File No. 170893

AGENDA PACKET CONTENTS LIST

Subject: Appeal of the June 22, 2017, Planning Commission Decision and the June 23, 2017, SFPUC Decisions Regarding the Alameda Creek Recapture Project.

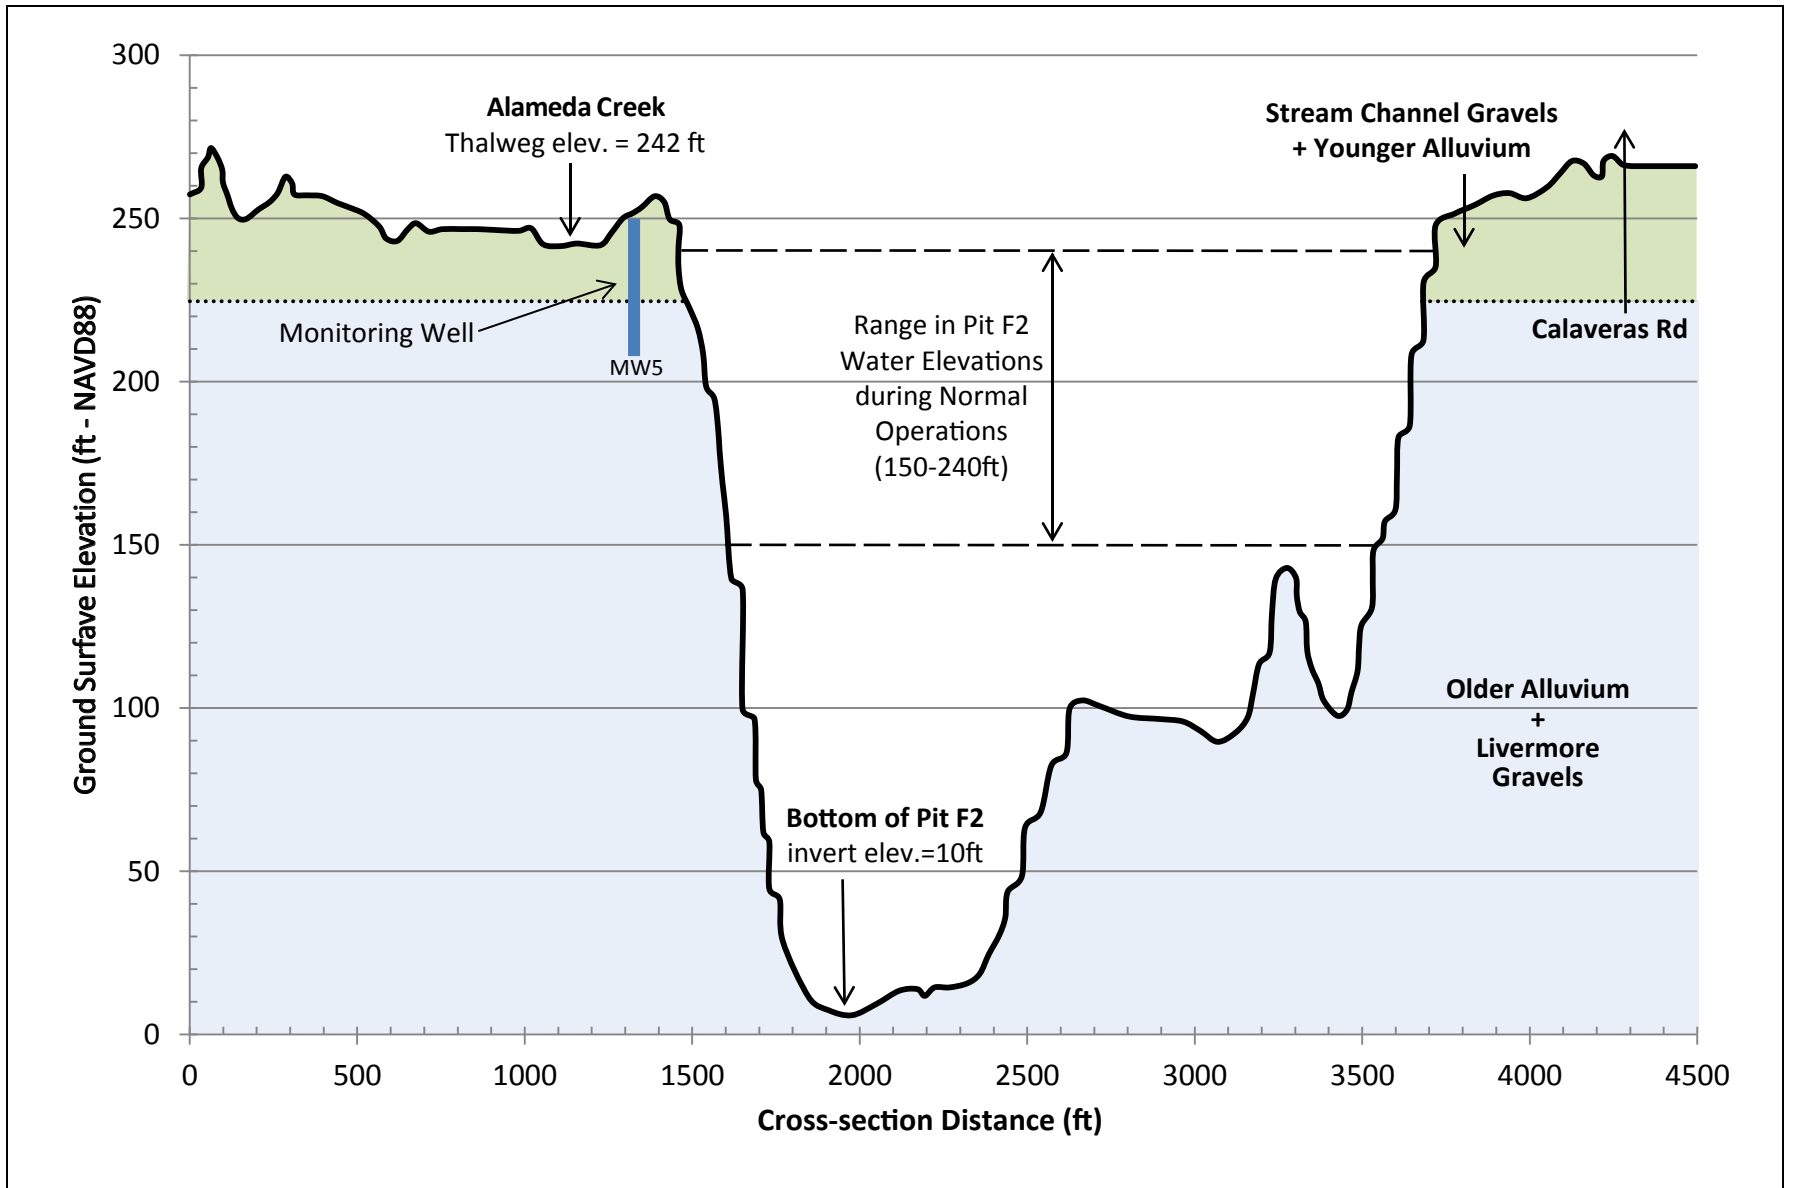
Comment A-19 further states that "the ASDHM modeling assumes that under project conditions the loss rate of surface water from Alameda Creek will not change relative to current conditions, when in reality the project will lower local groundwater levels and increase surface water loss rates, which will impact downstream flow rates." Comment E1-6 states "the modeling analysis makes no effort to reflect changing stream losses, nor are changing stream losses reflected in the FEIR's impact analysis." Neither of these assertions is valid for the reasons described below.

As discussed below under *EIR Groundwater Model*, investigations have shown that surface water in Alameda Creek percolates into the subsurface in the reach between Welch Creek and the confluence of Alameda Creek with Arroyo de la Laguna. Furthermore, this subsurface flow is limited within the boundaries of shallow, thin alluvial materials deposited along the alignment of Alameda Creek. The LSCE groundwater analysis found no evidence that groundwater from other sources, such as the underlying Livermore formation or older basement complexes in surrounding areas, contribute to subsurface flow to any significant degree in the project area. The project would not change any of these physical characteristics, and the percolation of surface water to the subsurface in this stretch of Alameda Creek will continue to occur under the same circumstances as it does now when the CDRP instream flow schedules are implemented and if the ACRP is implemented.

Pit F2 is about 240 feet deep. Near Pit F2, the shallow alluvium is approximately 25 feet in thickness. Underlying these alluvial materials are the impermeable Older Alluvium and Livermore Gravels formations that are high in clay content and the primary targets for aggregate mining in the Sunol Valley. Pit F2 extends 25 feet through the shallow alluvium and another 215 feet through these deeper impermeable Older Alluvium and Livermore Gravels (see **Figure 5.16-12** from the EIR, shown on the following page). Only the upper ten percent of Pit F2 is hydrologically connected to the shallow underflow from Alameda Creek, and the large majority of water collected in Pit F2 is stored below the contact with the deeper impermeable geologic materials.

Example: Actual CEQA Date-January 2007

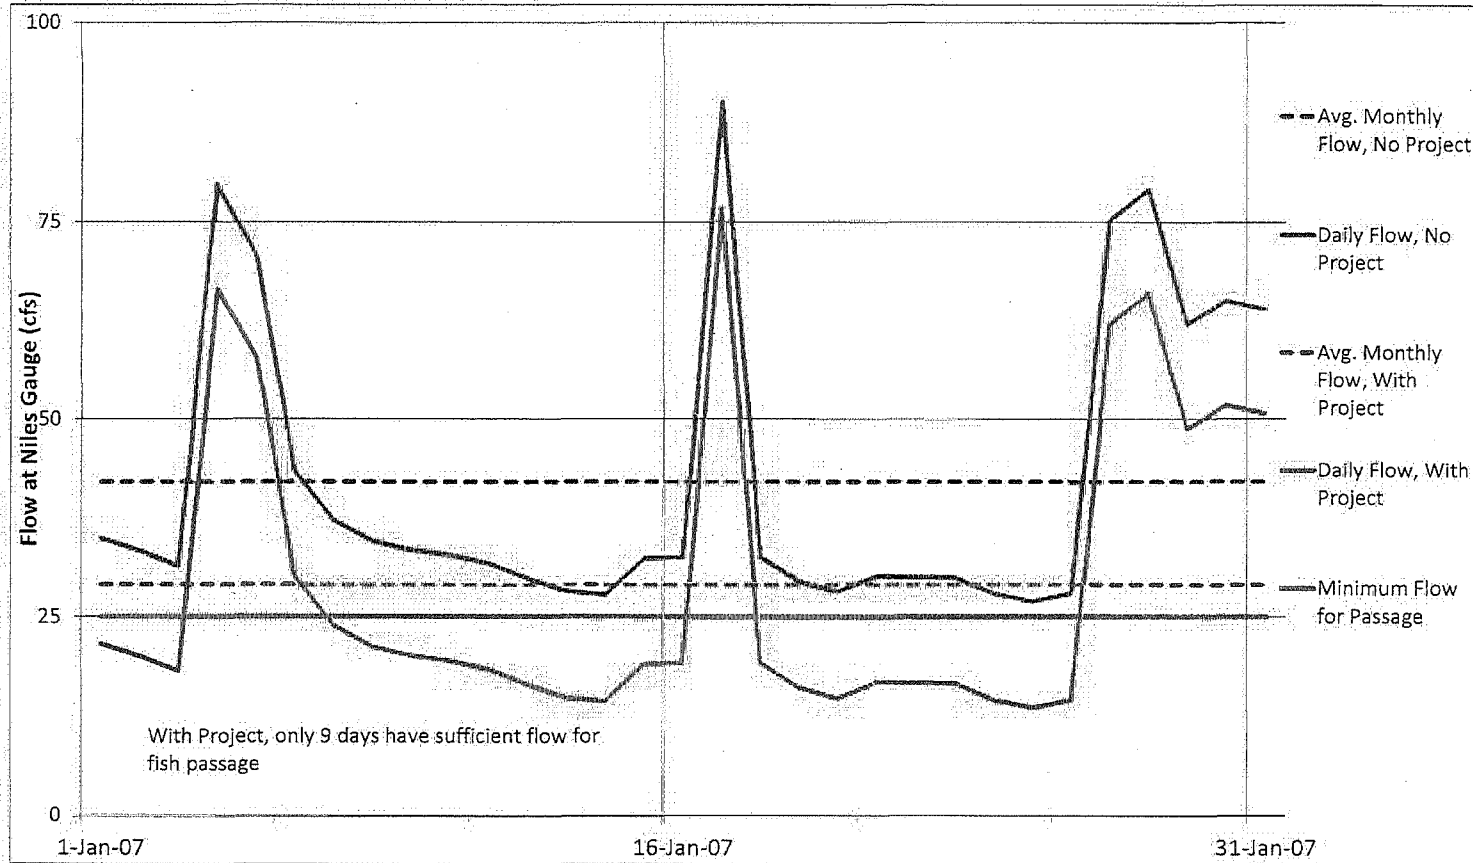
- Monthly data for both "With Project" and "No Project" exceed the minimum flow requirement for fish passage (25 cfs), which might suggest that the Project does not have an impact on fish.
- However, the Daily data used to generate those monthly values indicates that while the "No Project" scenario has sufficient flow for fish passage every day of the month, "With Project" will reduce that to only 9 days of sufficient flow.
